## Product Change Notice (PCN)

PCN Number: **PCN-0450024R-01**

Product(s) Affected: **PJ-075DH-SMT-TR**

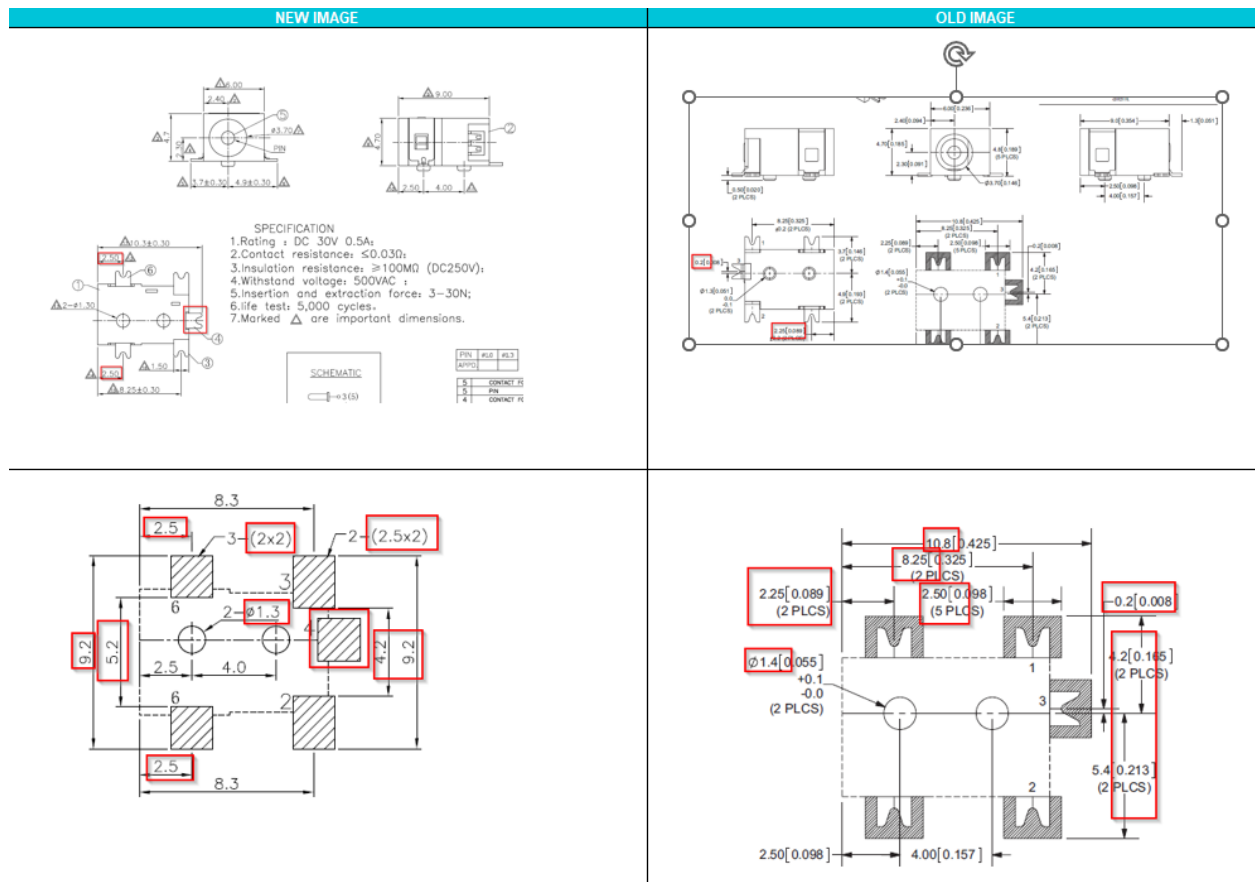
Description of Change: **Minor Housing and footprint differences. Material Change on the housing and terminals. See image Below**

Housing and Terminal Material Changes:

Center Pin: Copper to Brass

Terminal 2: Copper Alloy to Brass

Plastic: PA6T or Equivalent to PA9T
